Modification Bulletin

RIGOH Modificat		tion B ulletin				PAGE: 1/	
Model: Model C – P1			Date: 2-Oct-03			No.: MG094001	
Modified Article: Rubber Foot				Prepared	bу: т.	Shintani	
From: 1st Technical	Dept.						
Reason for Modification:	 Parts catalog correction To facilitate assembly Part standardization 		•	ange e reliability	☐ To n (neet standards)	
Modification Schedule:	After the old parts have beco	me out of	stocł	۲.	<u>.</u>

Model: Model C-P1

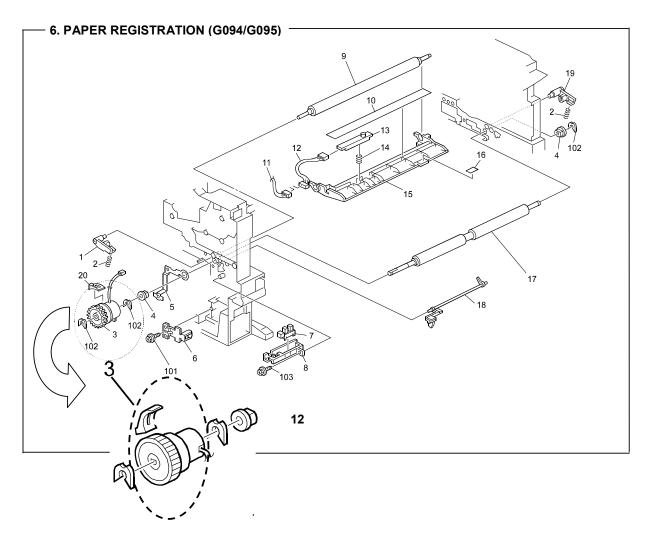
Incorrect	Correct	Description	Q'ty	Int	Page	Index	Note
Part Number	Part Number						
AX200208 ¬		Magnetic Clutch – Z45	1→0	- / -	13	3	*
G0763321		Clutch Sleeve Cover	1→0	- / -	13	20	*
L	-▶ G0763205	Magnetic Clutch : Registration : Ass'y	0→1	- / -	13	3	*

Note: The illustration for the magnetic clutch assembly has been corrected as follows:

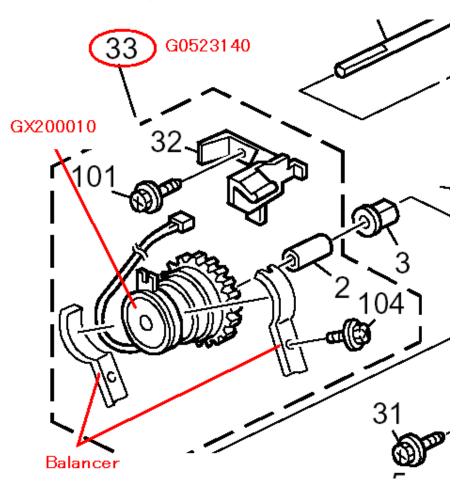
Incorrect Part Number	Correct Part Number	Description	Q'ty	Int	Page	Index	Note
GX200010		Magnetic Clutch	1→0	- / -	11	1	*

Change: The GX200010 magnetic clutch was deleted from service parts. **Reason:** This part was registered as a service part by mistake.

Note: If you need to replace this magnetic clutch, order the Magnetic Clutch Assembly (**G0523140**, index #33).
